Location	Russell Square Proposed Ticket Hall
Line	Piccadilly
Title	PROPOSED TH LAYOUT

DRAWING NUMBER	FfF-LUL-PRM-M169-DR-K-0200
REV	F

Photo 2

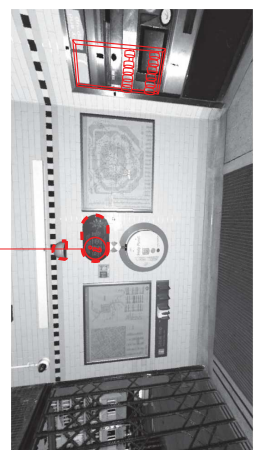
New Info Point:
To comprise of 2No. QRs placed on either side of the existing PHP and a Leaflet Rack/DR on the adjacent wall. A small 'P' sign to be fixed in between the QRs. Remove the PHP - see Photo 2.

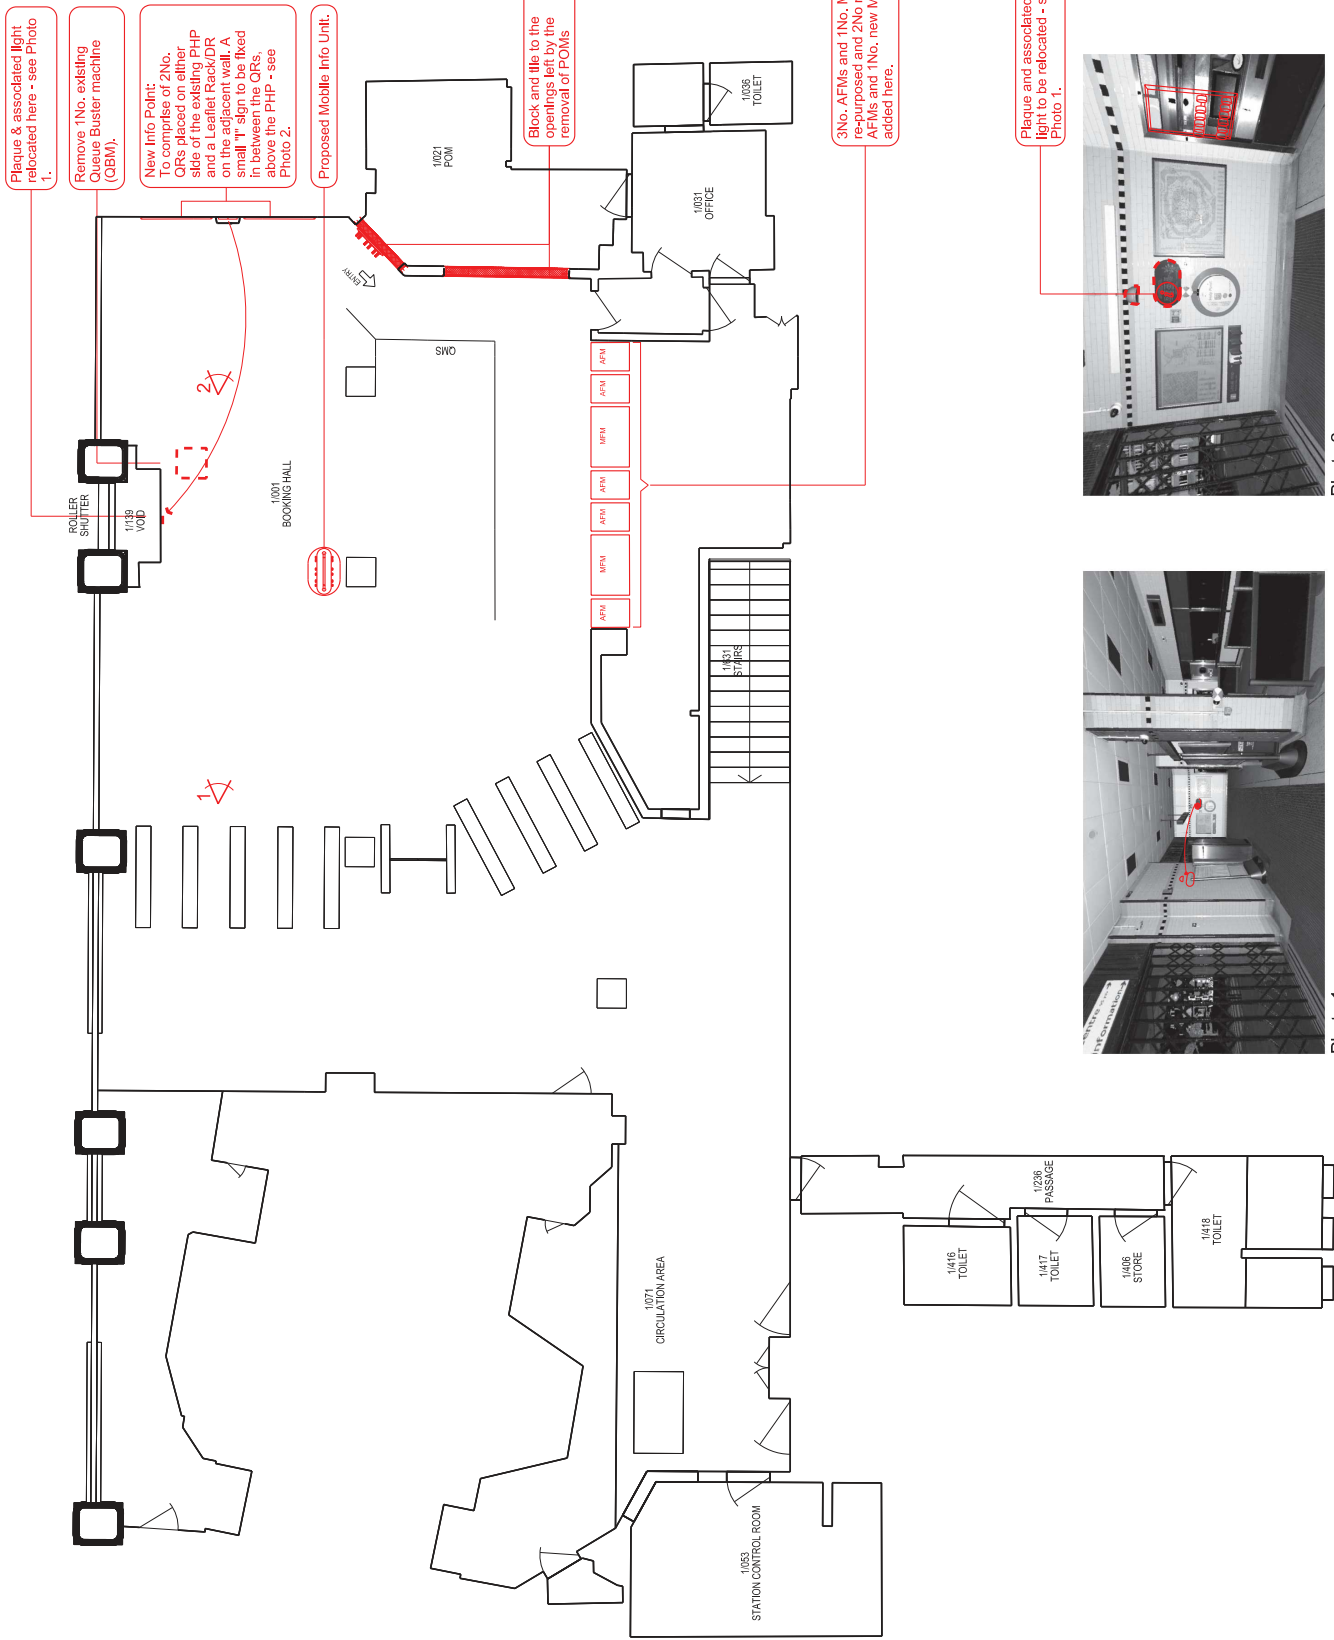
Plaque & associated light relocated here - see Photo 1.

Remove 1No. existing Queue Buster machine (QBM).

Proposed Mobile Into Unit.

Block and tile to the openings left by the removal of POMS

3No. AFMs and 1No. MFM added here.

Plaque and associated light to be relocated - see Photo 1.
